Crystal River Unit 3

GSI-191 Strainer Fiber Bypass Test Plan November 1, 2012

CR3 Strainer Fiber Bypass Test Plan

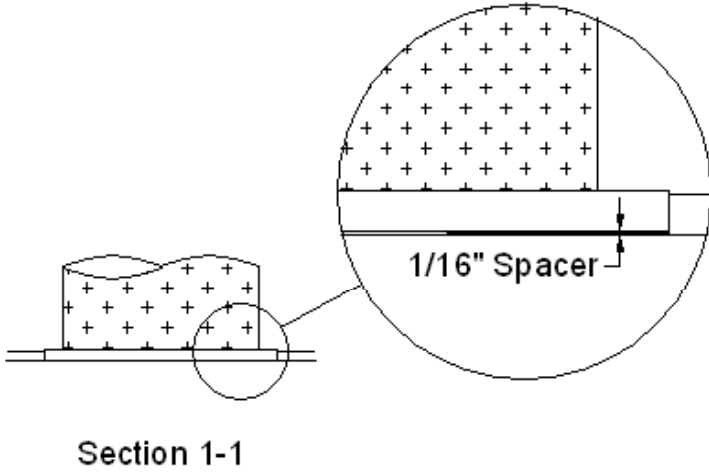
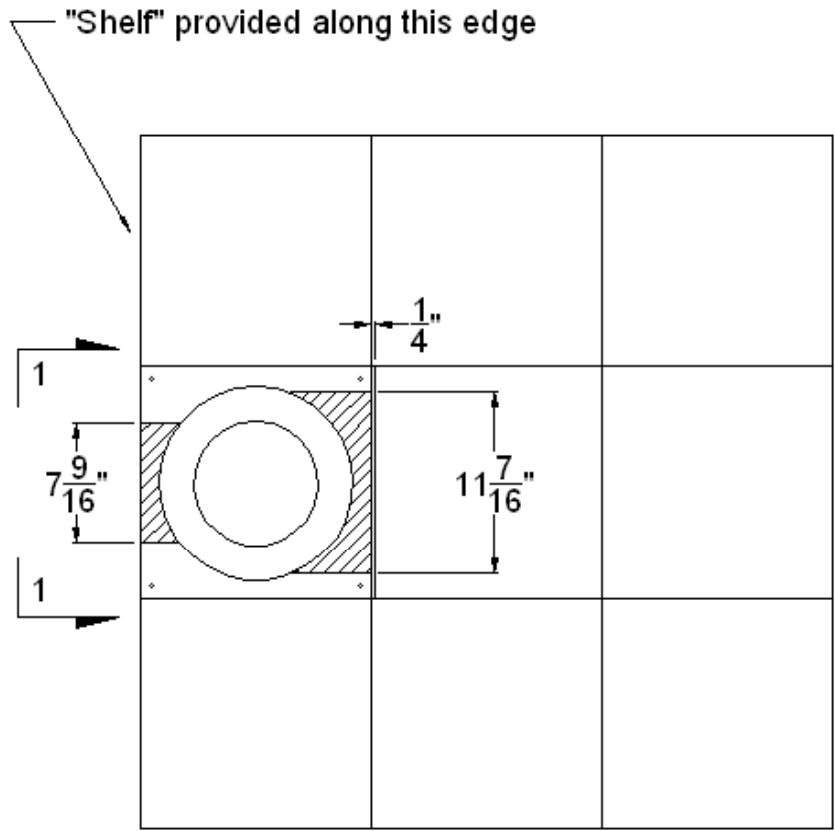
4. How is it validated that the filter bypass valve (SBV-01) is fully seated prior to the initiation of the test and that all flow is through the intended filter (not other filters, etc.)?

SBV-01 is a lever-operated butterfly valve, providing positive position indication. To demonstrate seating performance, pre-test and post-test instructions utilize drain valve PD-01 to check for valve leakage. Flow through the stand-by filters is prevented by double valve isolation (inlet and outlet).

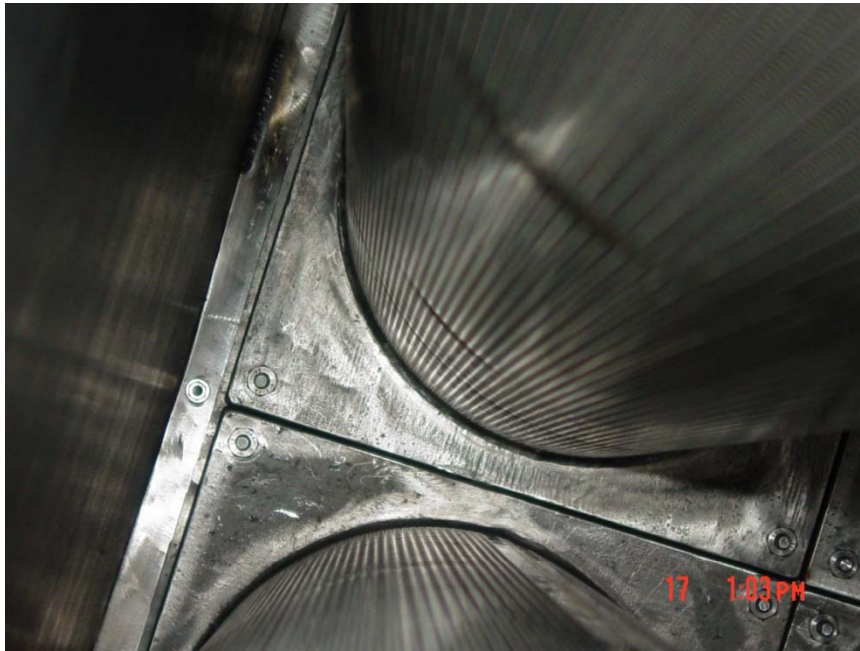
5. Under section 4.1, could a diagram or additional discussion regarding the gaps and dimensions be provided? The written description is difficult to understand.

See following drawing and pictures:

$\frac{1}{16}$ " gap between top hat base and plenum frame

Note: Interior gap can be on any of the three interior sides
